Product Change Notification (PCN)

PCN Number	508462	Date Issued	April 01, 2021
Reason for Change	Change to Product		
Change Type Description	This letter is to inform you that changes are being made to the part(s) identified in this Notice. The change may affect the fit, form, function or appearance of the parts, or it may result in a change to the specification. The pictures below show an example of the possible differences.		
Assessment of Change	Product will be fully qualified before it is shipped. Qualification reports will be available after below listed date		
Internal Molex Qualification Date	October 29, 2021		
Sample Availability Date (Changed Part)	October 29, 2021		
Planned Implementation Date	December 31, 2021		
Method of Identifying Change	No special marking on the product or packaging

- Molex decided to change design of Ultra-Lock sleeves

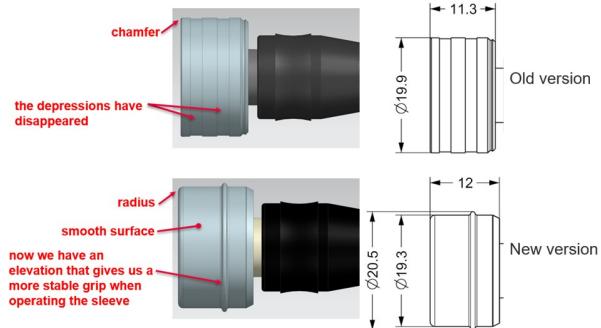
- No new color
- Mating feeling is the same
- Function is the same
- Small change in the diameter +0,6mm
- The sleeve will generally be made of a higher quality material → stainless steel
- Better grip with the new sleeve
- Smoothen surface on the sleeve
